Addendum 02 for RFB935800-01

Project Name: Lucas ICN CRAC Replacement
DAS RFB #: 935800-01
DAS Project #: 9358.00
Date: 6/18/24

Contents:

FIRST FLOOR DEMO PLAN - ELECTRICAL

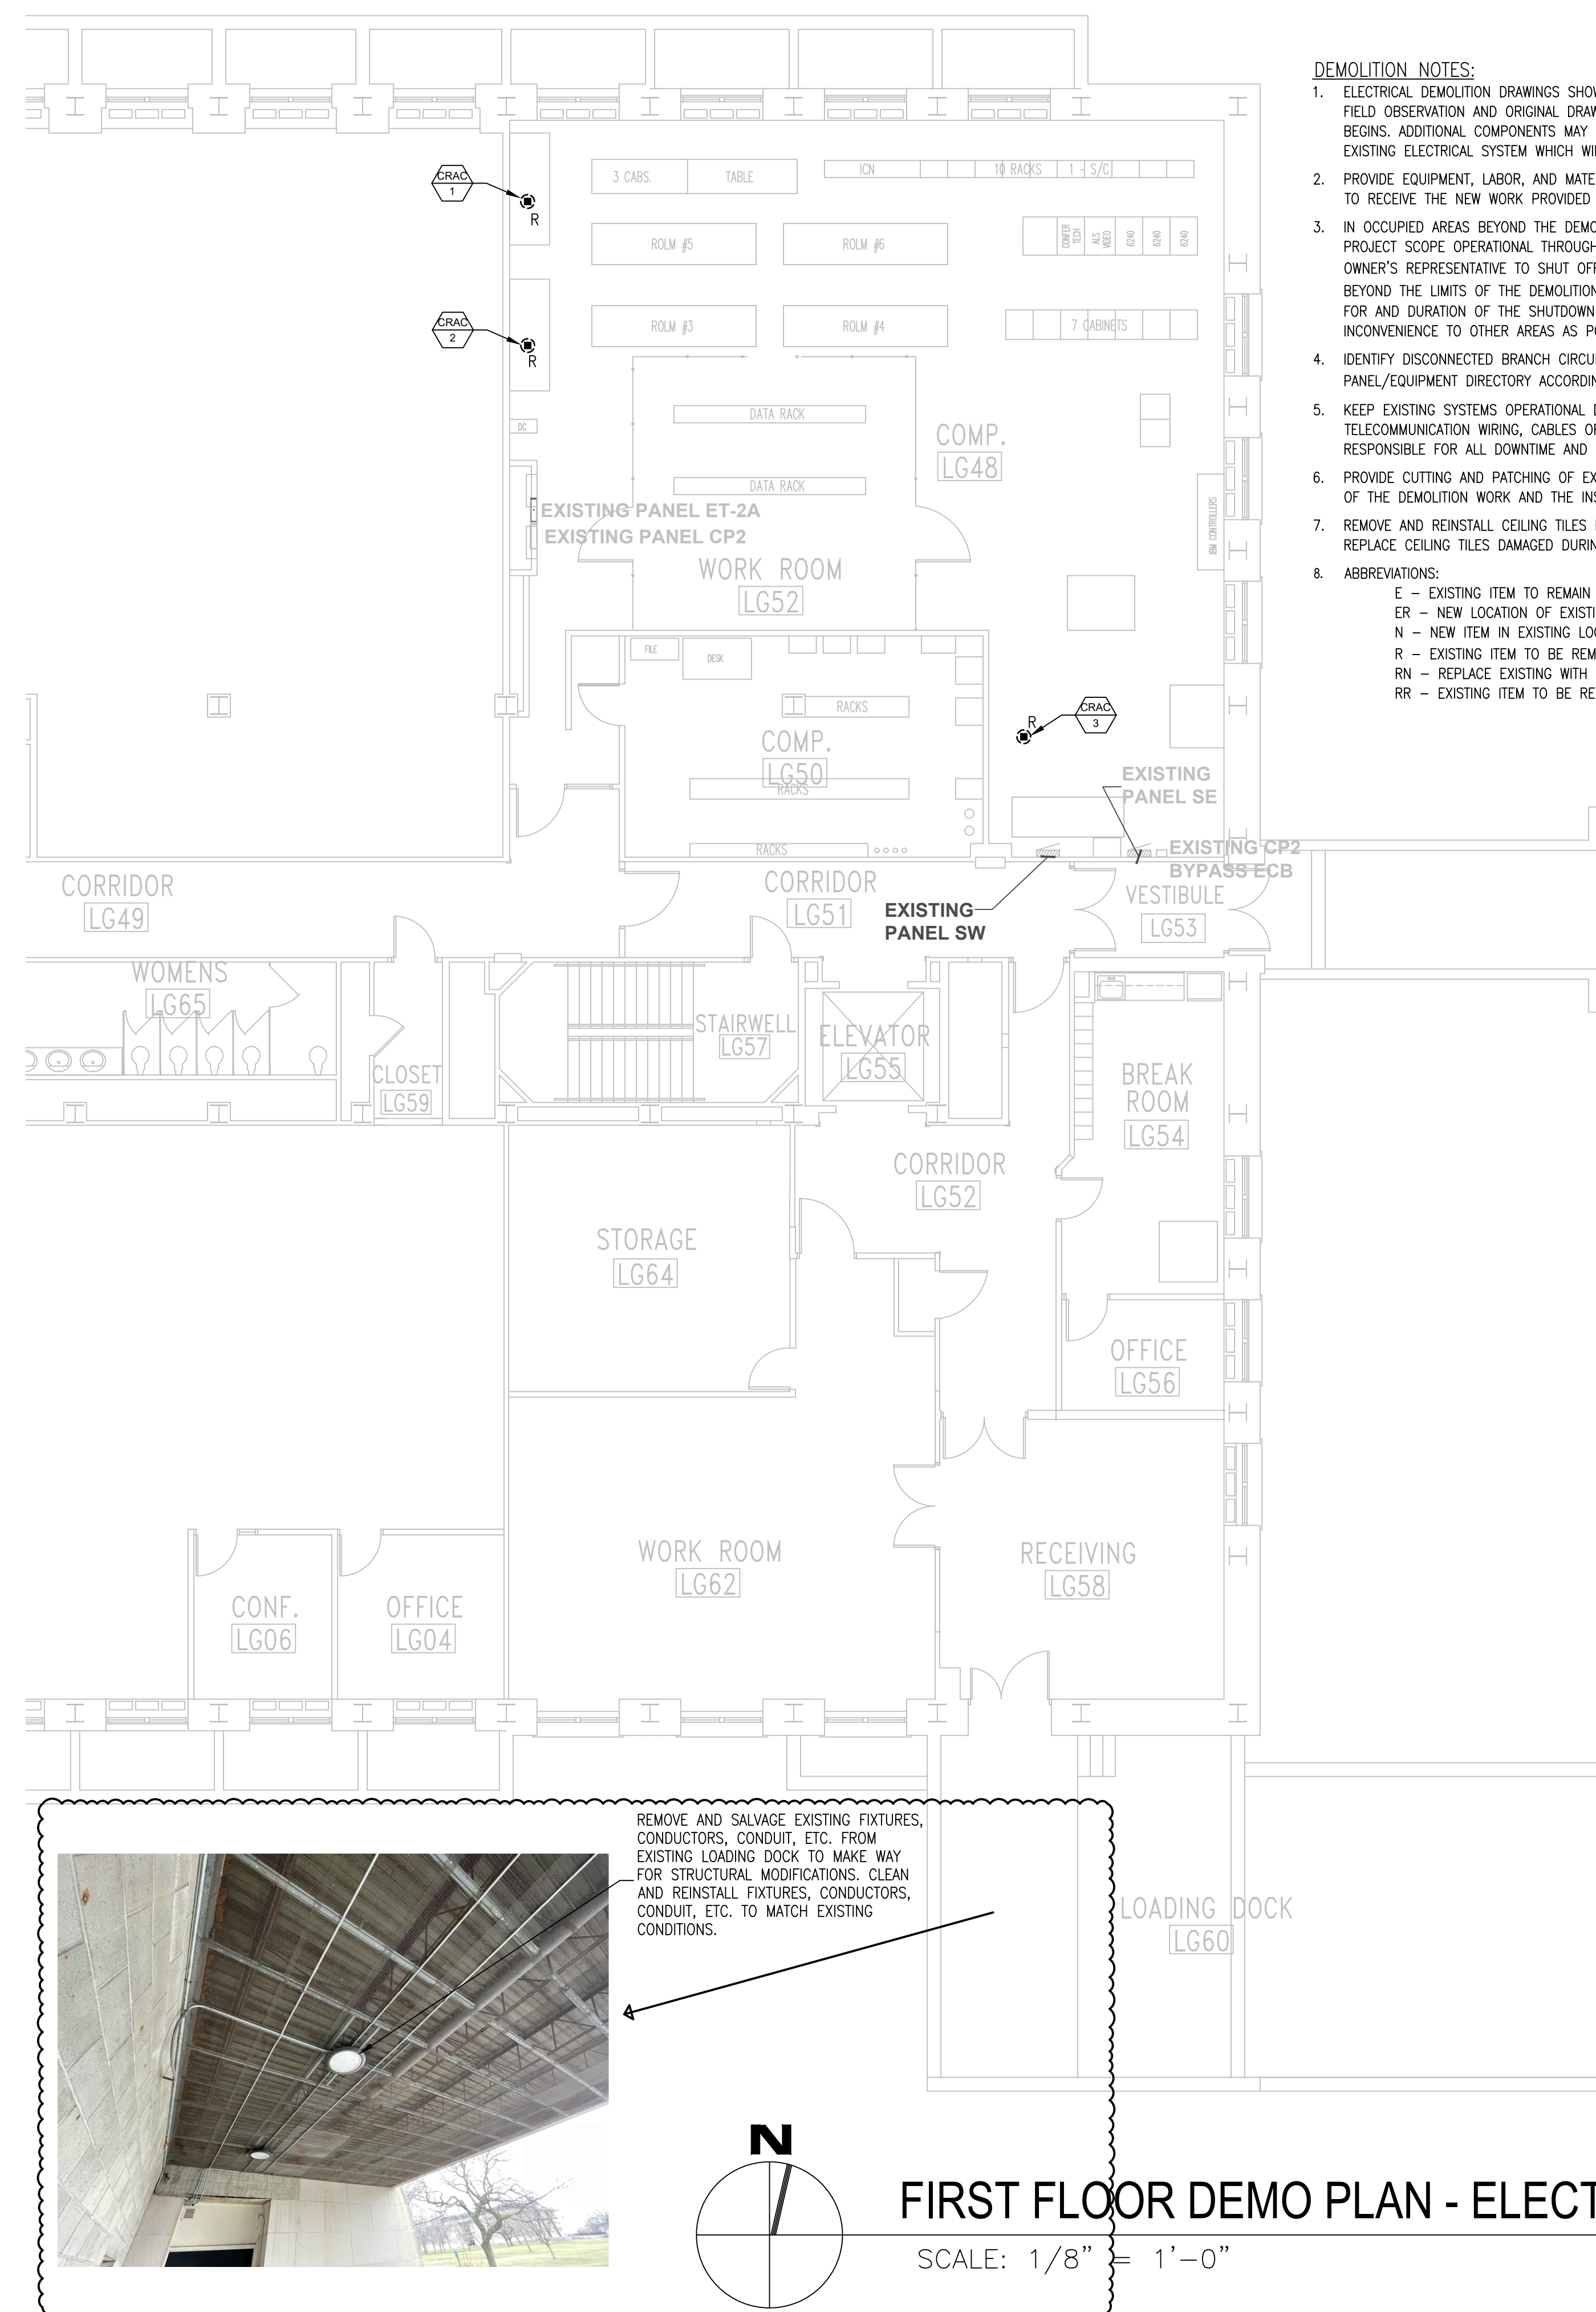
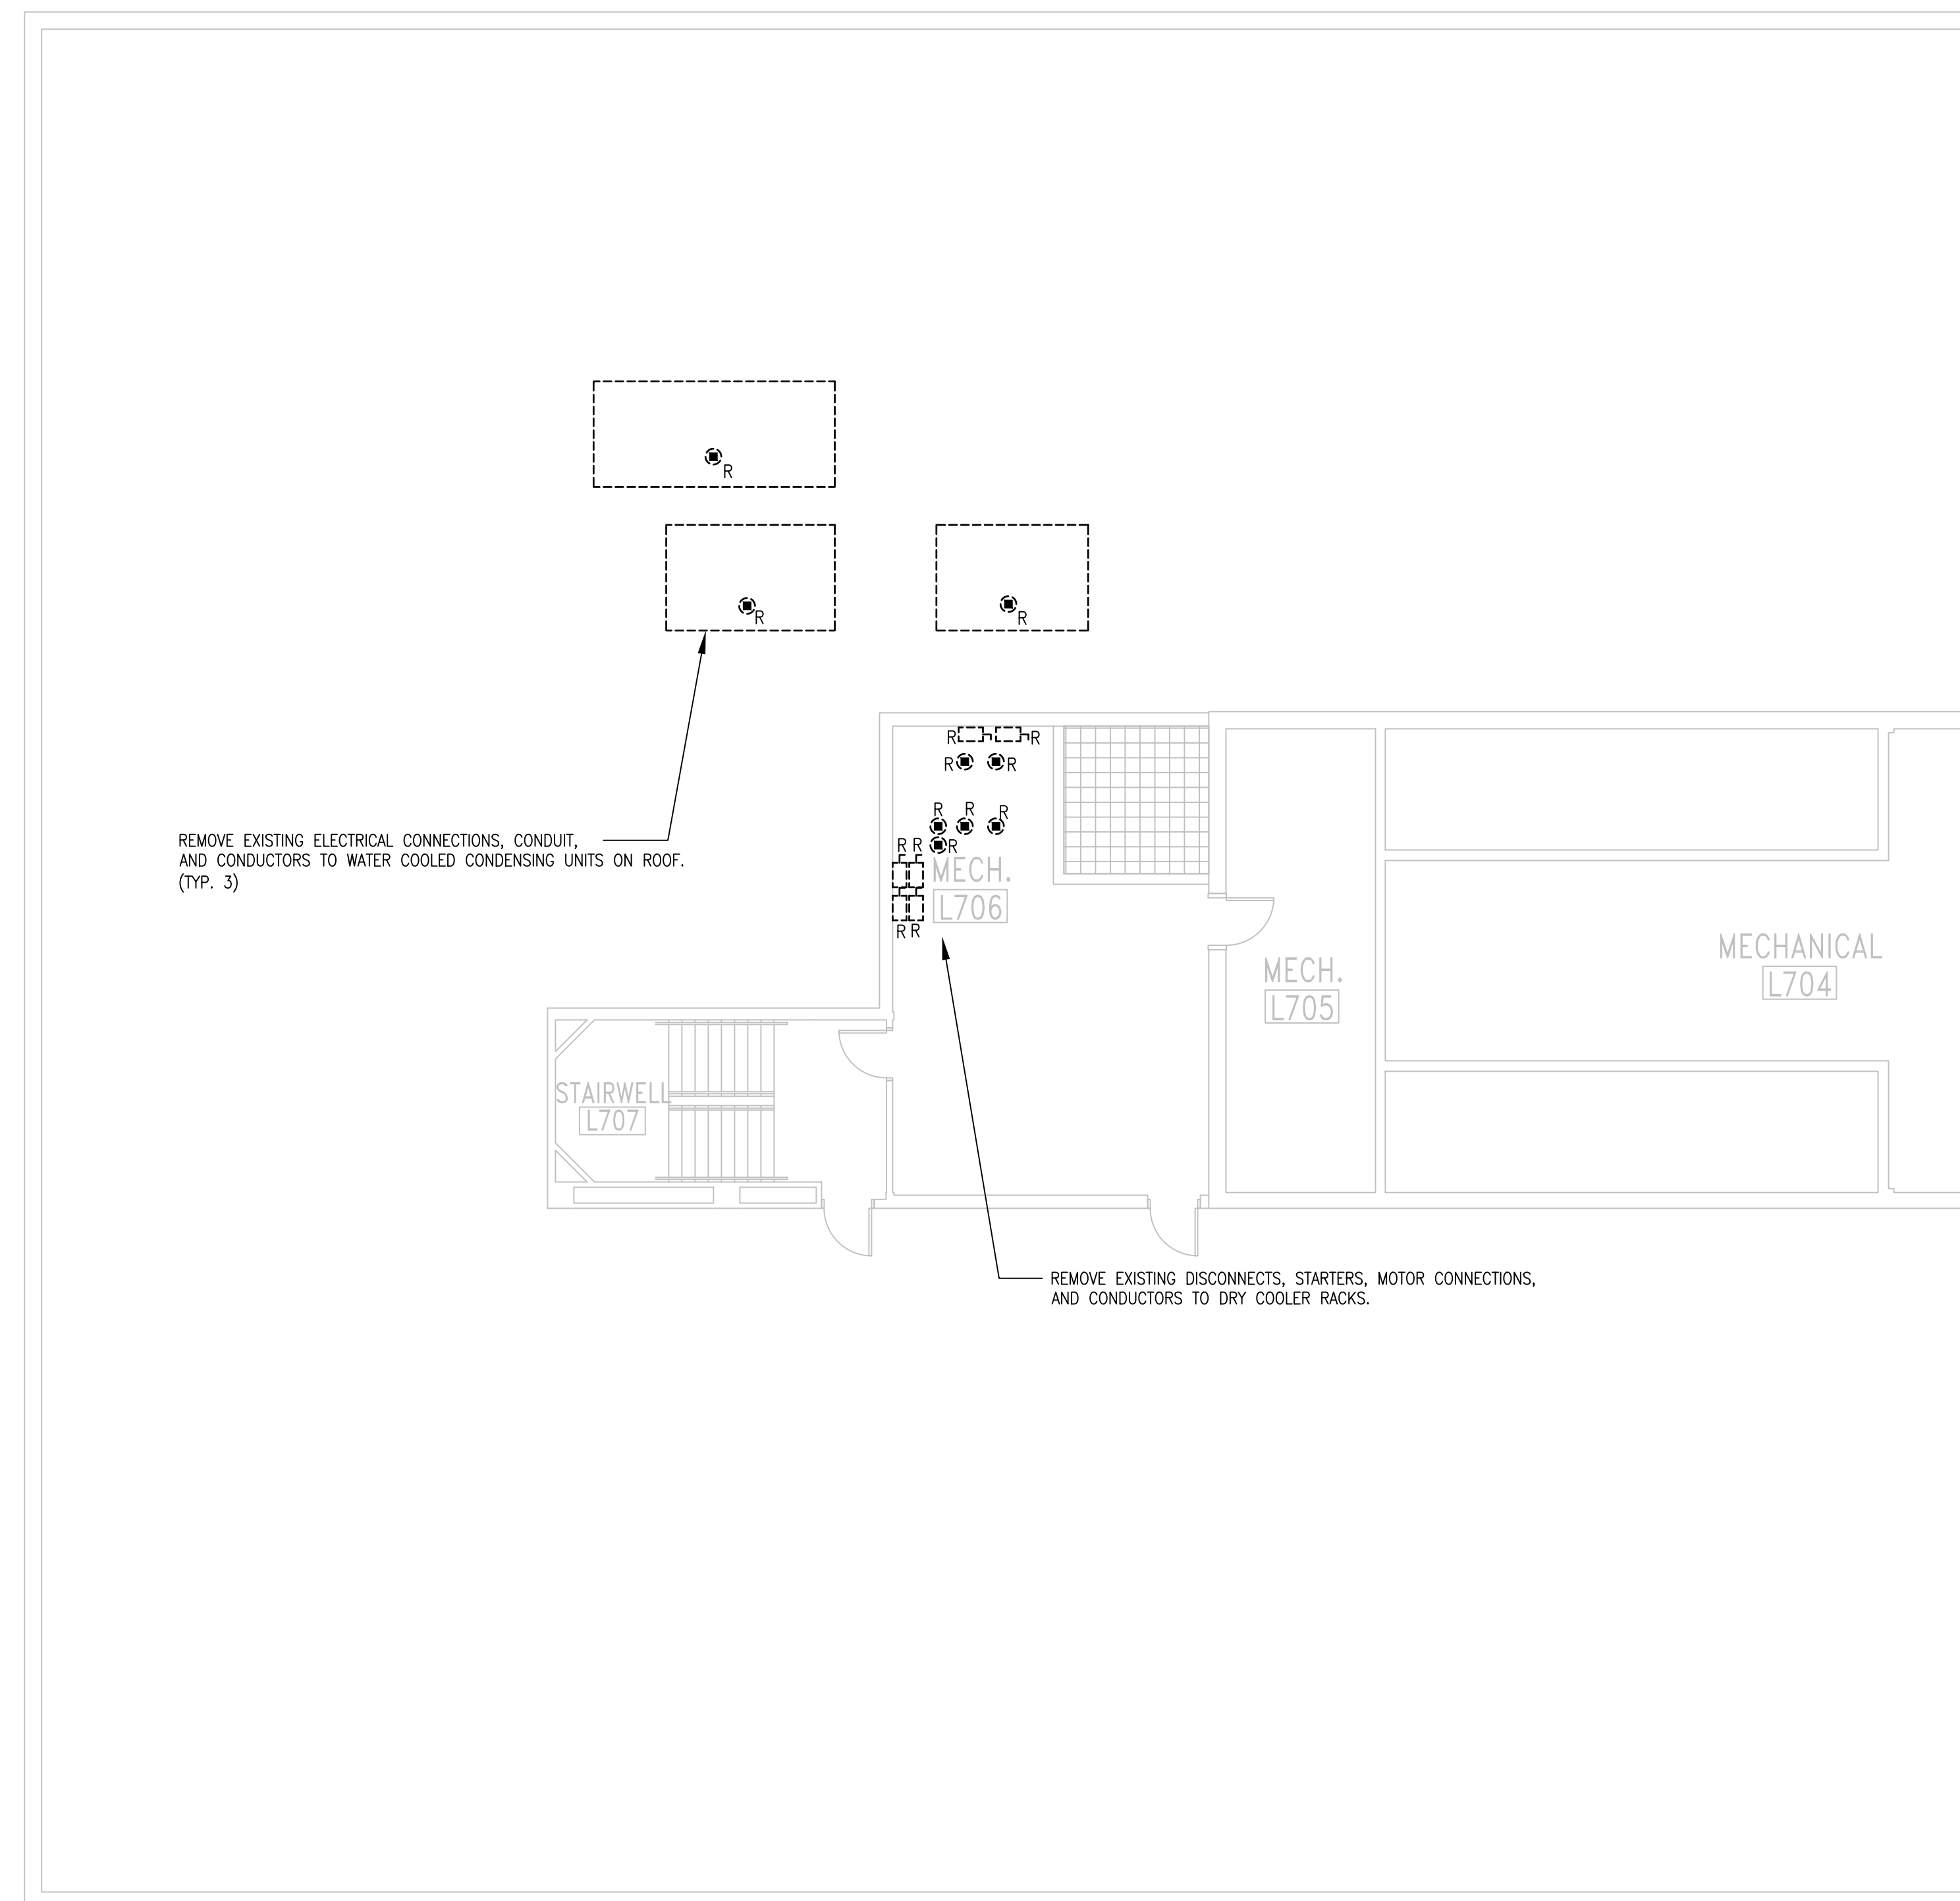
1. Drawing ED1 – Electrical Plan
 - a. ADD removal and reinstallation of loading dock lighting.
 - b. Refer to attached full size sheet ED1.

1 ROOF FRAMING PLAN
 1/4" = 1'-0"

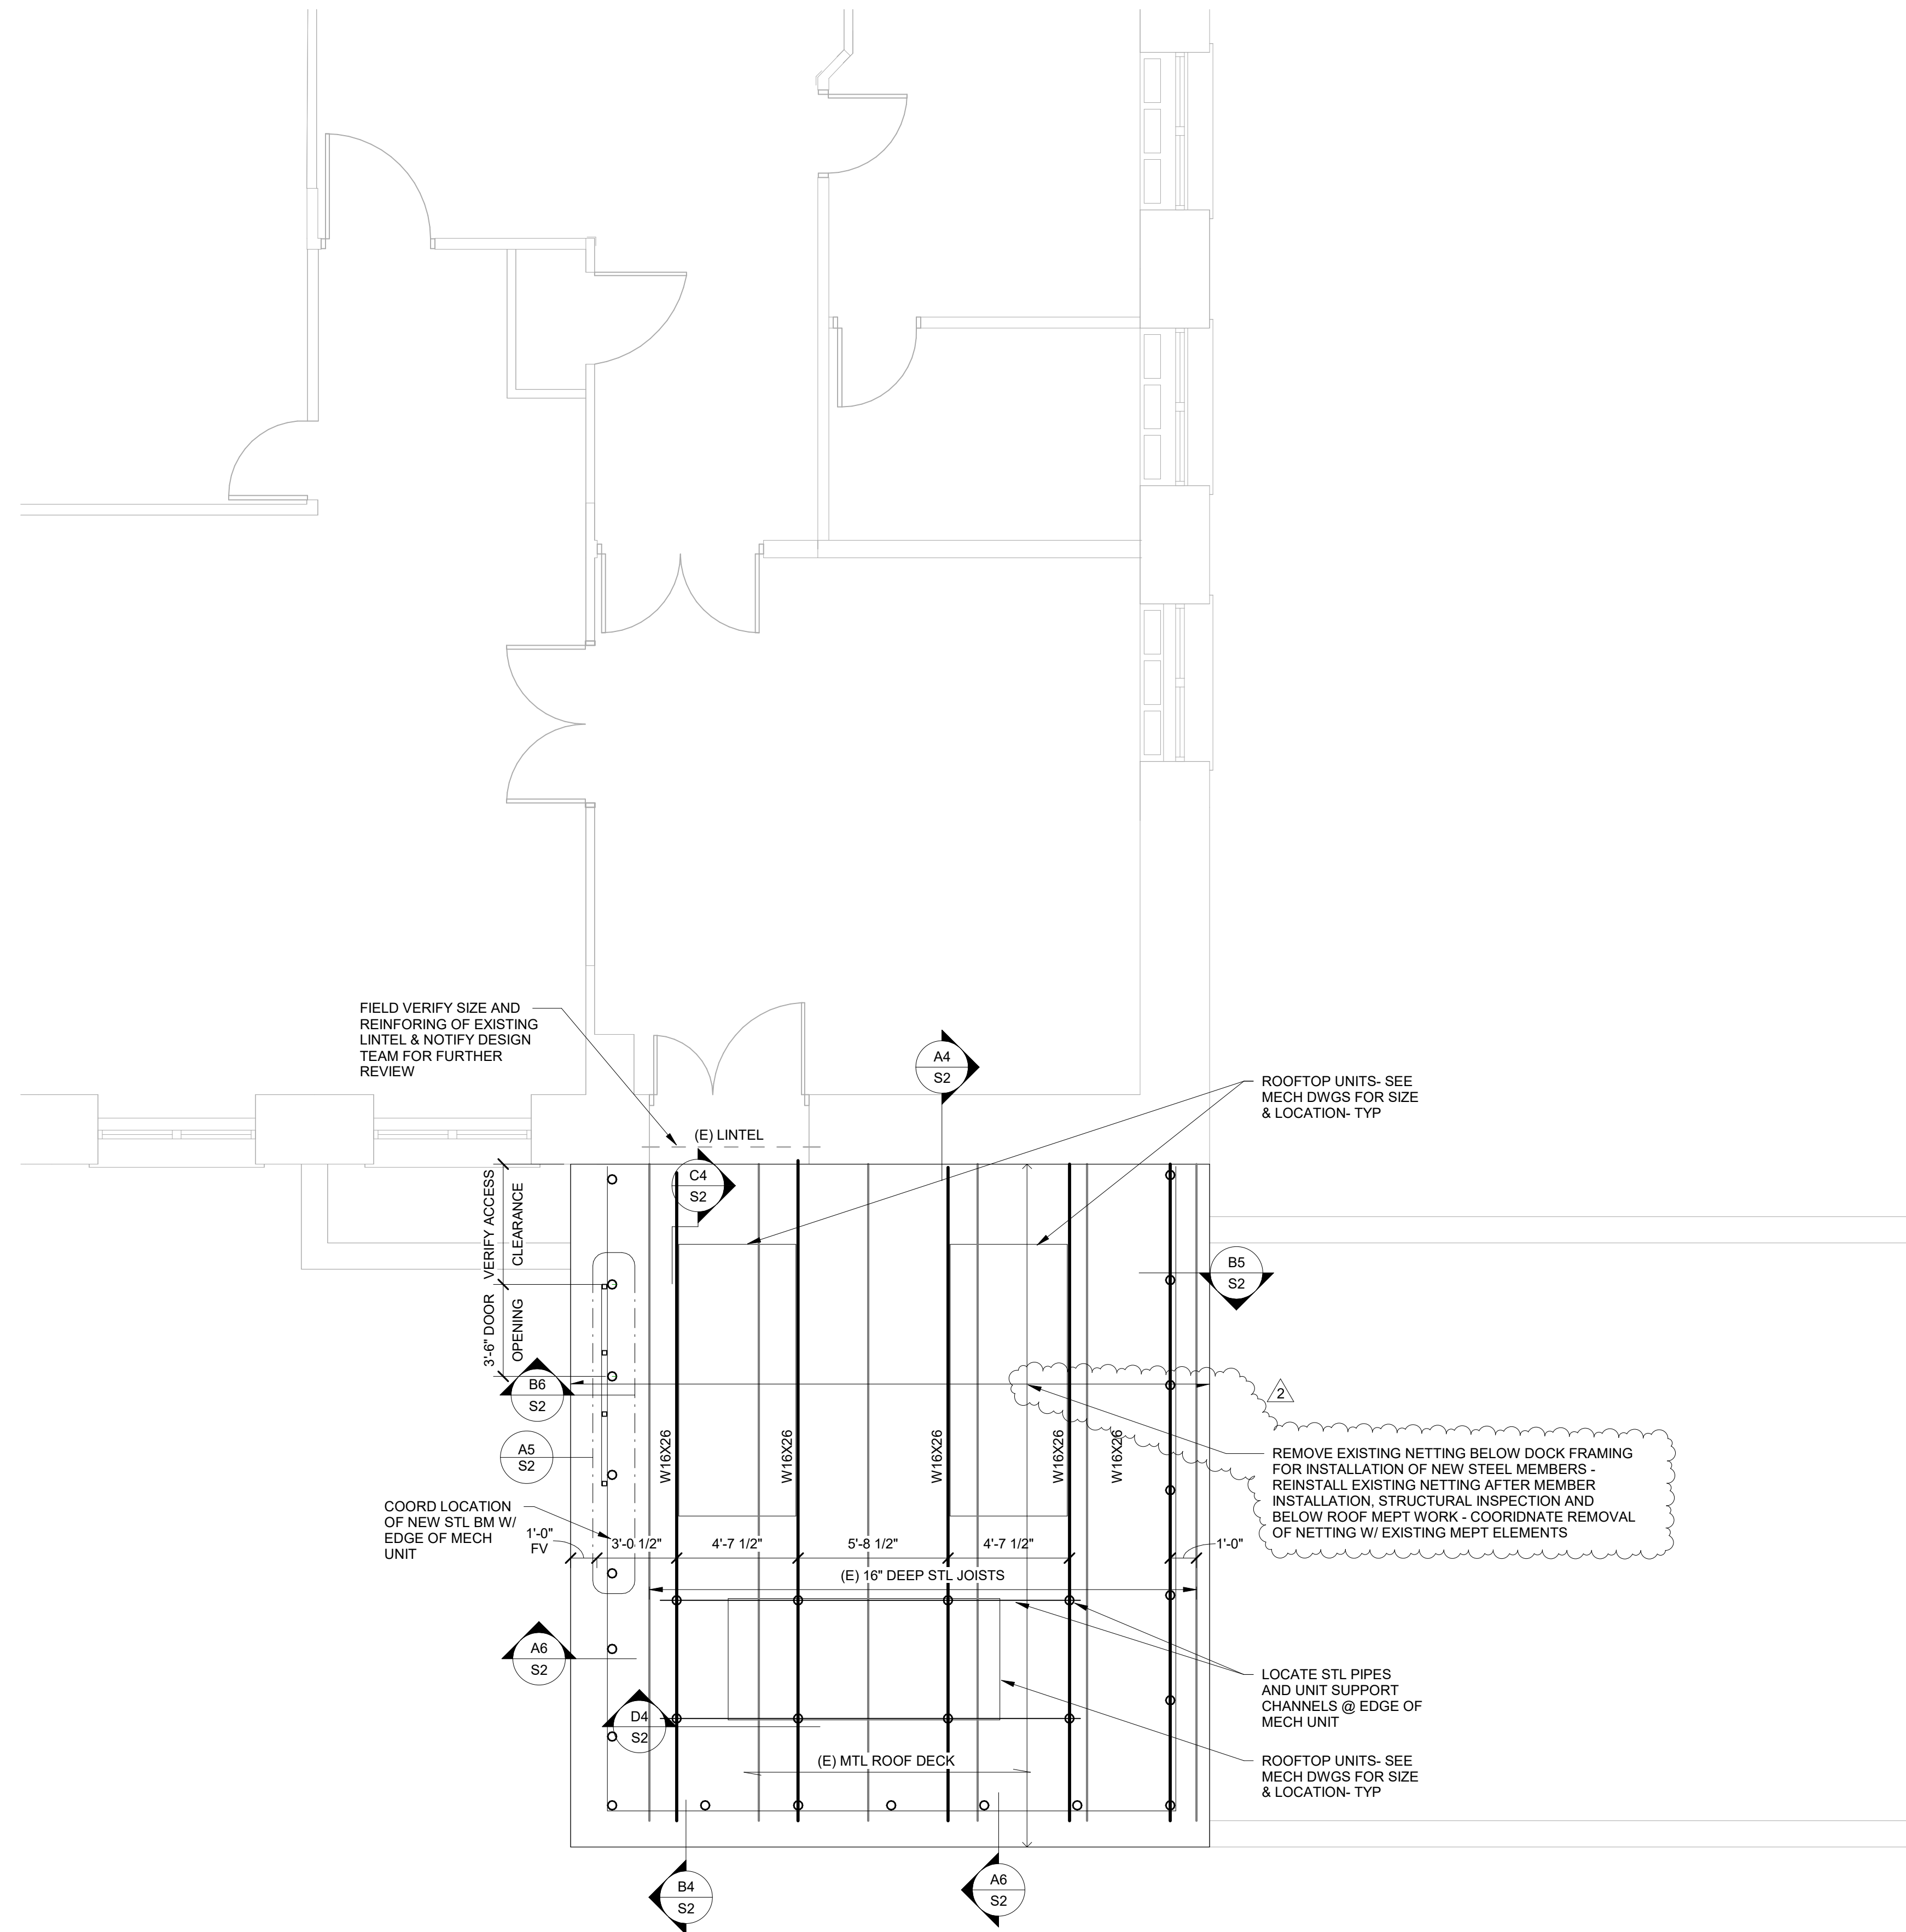
1. Drawing S1 – Structural Notes & Roof Framing Plan
 - a. REVISE note MP3.
 - c. ADD note for removing and reinstalling existing netting to ROOF FRAMING PLAN.

MP3) Contractor to provide manufacturer standard deck color options to owner for selection and approval. Provide basis of design two-coat fluoropolymer level of finish.
